FC312E is a Cordless Phone which only supports GSM band. The GSM frequency band includes GSM850 and PCS1900.

The original one and the modified one support the same function.

The PCB is different. The differences between the original and the modified are: the modified one replaces one component on the PCB, because the new component has different hardware interface, so the PCB layout has little changed to work in the new component.

The photos of the two FC312E:

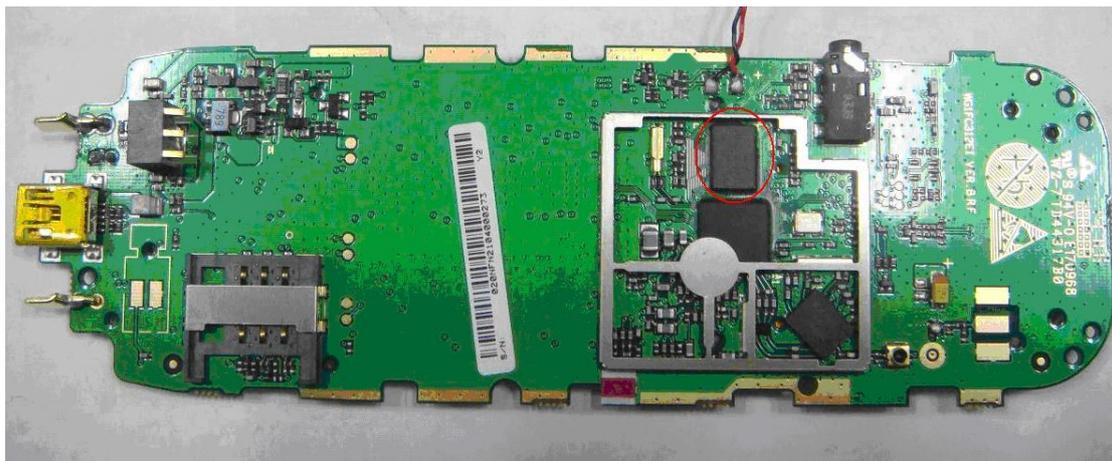
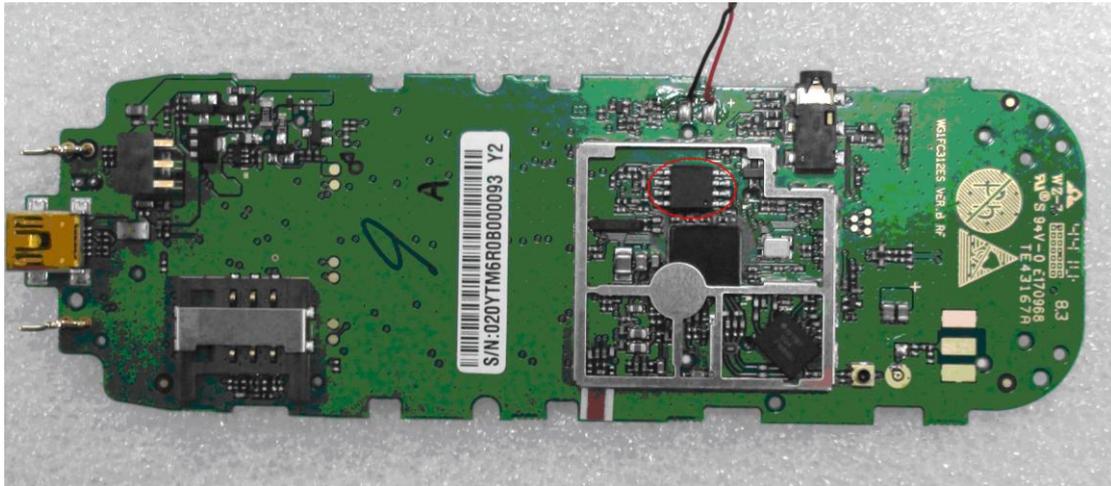
| | FC312E(the original) | FC312E(the modified) |
|--------------|----------------------|----------------------|
| FLASH | Support 32M | Support 32M+64K |

The old one use ADMUX Flash with parallel interface, and the new one use SPI Flash with serial interface. The two kinds of flash have different pin number, encapsulation and size; ADMUX Flash is BGA enveloped, SPI Flash is SOP enveloped, but the two perform the same function, therefore, the PCB layout has little changed to work with the new component.
